SITE AND ARCHITECTURAL REVIEW COMMITTEE

MEMORANDUM

Subject: Site and Architectural Review Permit

File No.: PLN2019-239 ~ 1789 Hurst Avenue

Figures 1 & 2 – Existing vs. New Second Floor Plan

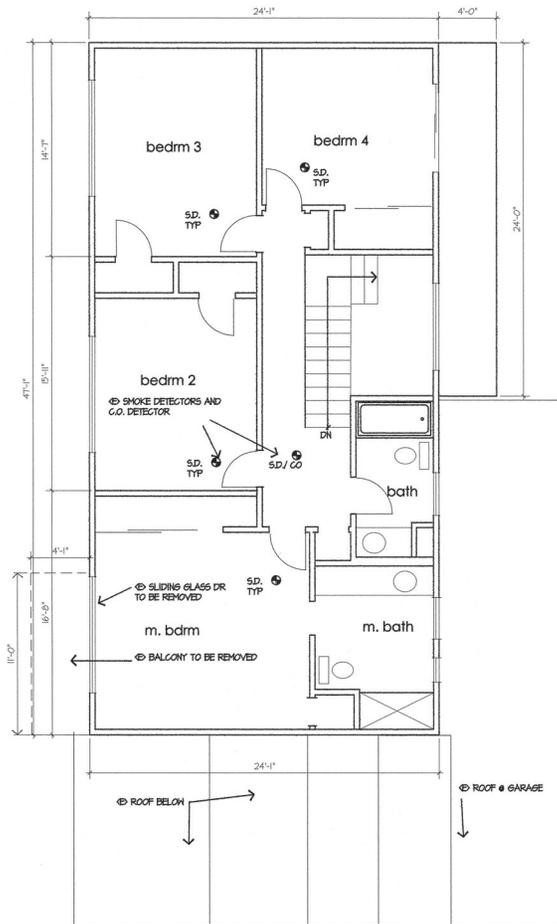
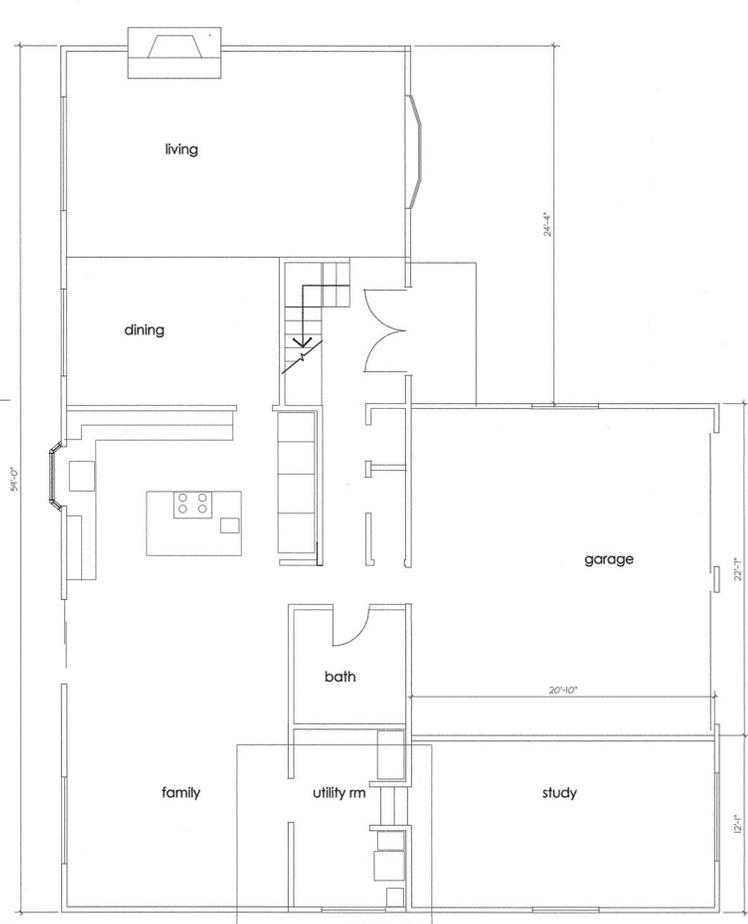
Reduced Side Setback: The applicant’s request would allow for a 5-foot second-story side setback where 10-feet would otherwise be required. In consideration of the request, the following findings must be made:

- a. **The side setback would not be detrimental to the health, safety, peace, comfort or general welfare of persons in the neighborhood, or the city as a whole; and**
- b. **The side setback would not unreasonably interfere with the ability of adjoining property owners to enjoy access to air, privacy, sunlight, and quiet enjoyment of the owner’s property.**

As the addition would be designed to match the existing residence - any impact to the ‘neighborhood or city as a whole’ would be minimal to nonexistent. In relation to the adjacent neighbors, the applicant provided a Written Statement (reference **Attachment 3**) explaining how the project may improve the comfort, peace, and quiet enjoyment of adjoining properties through the removal and replacement of a second-story balcony and sliding door with two smaller windows. To further promote privacy, the applicant notes that the south side (interior side) of the existing second floor has no windows, and that no windows would be added with the new addition. Finally, in regard to access to air and sunlight, the proposed setback and placement of the addition would maintain adequate airflow between the properties and minimize the creation of shadows recognizing it would occur to the north of the closest adjoining property (sun creates the greatest shadows east to west).

Figures 3 to 5– Proposed Front/South Elevation and Existing North Elevation

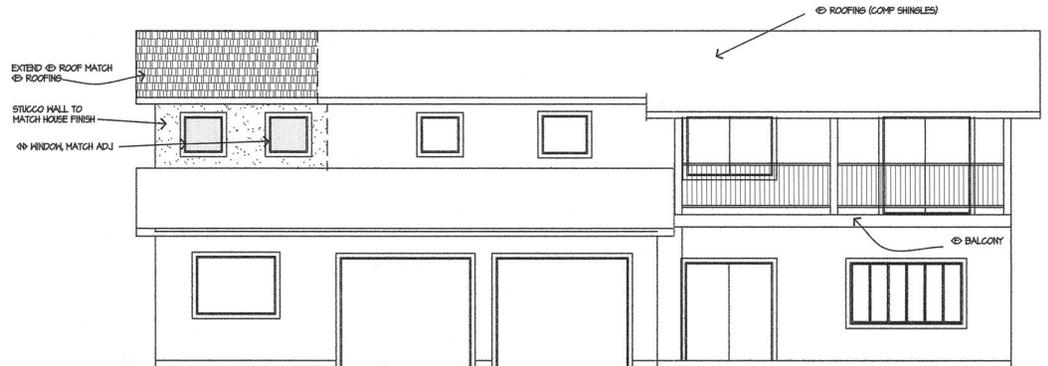
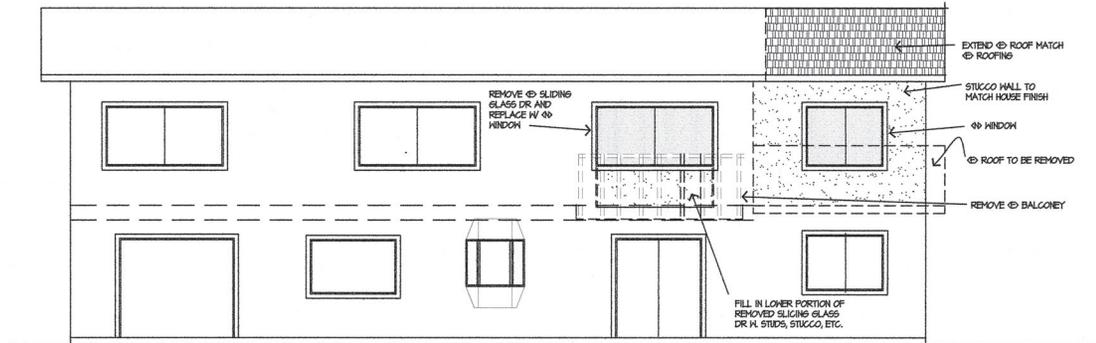
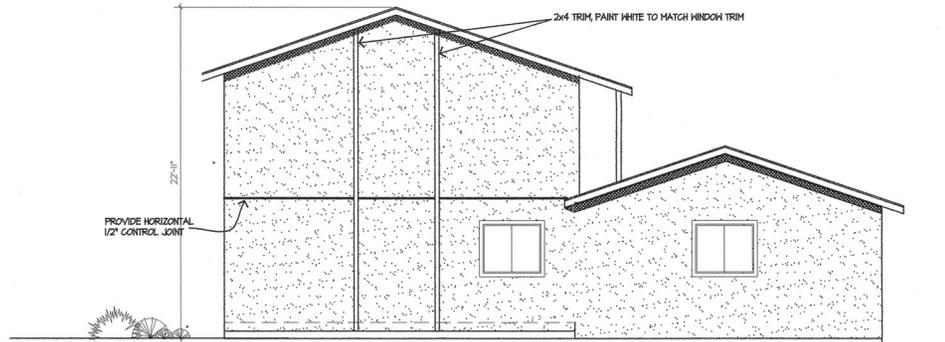
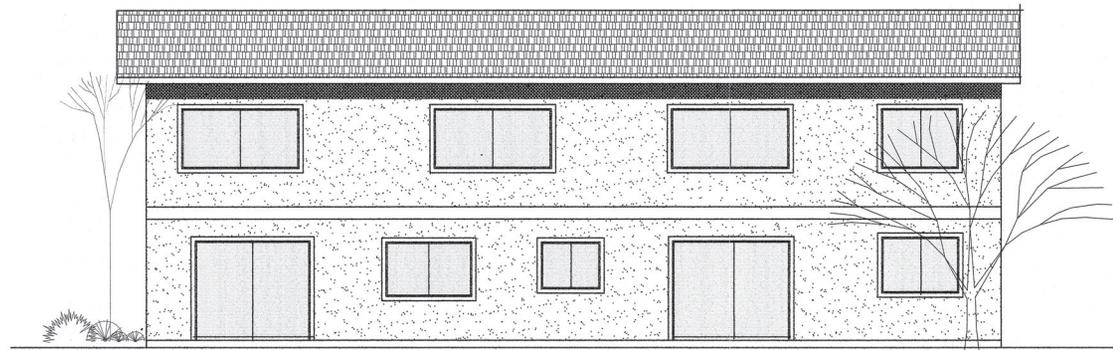
When viewed from the side, the proposed addition would ‘fill in’ the offset – bringing the second floor in line with the first. In order to improve the appearance of the solid wall that occurs as a result, the applicant has proposed to add a horizontal control joint and two trim boards running the height of the building. Beyond the trim presenting a potential conflict at the joint, the design features would be unique to this elevation and home. While such features do add visual interest, the SARC may consider requesting their removal in order to promote an appearance that is more consistent with the original home.

- Homes should be designed with relief in building facades. Long unarticulated wall and roof planes should be avoided, especially on two story elevations.**

The [City’s Design Guidelines for Additions to Single-Family Homes](#) would appear to discourage completely filling in the second floor in two ways. First the addition would increase the length of an already long and unarticulated roofline when viewed from the street. Second, when viewed from the side, the design would result in a relatively flat two-story wall where such relief is especially relevant.

In consideration of the City’s design guidelines, the SARC could request the applicant to explore offsetting the front or side elevation. One potential approach has been provided below for illustrative purposes:

- Should a reduction in interior side setback and/or increase in floor area ratio be supported?
- Should the horizontal control joint and vertical trim be removed?
- Should the applicant exploring offsetting the front or side elevation?
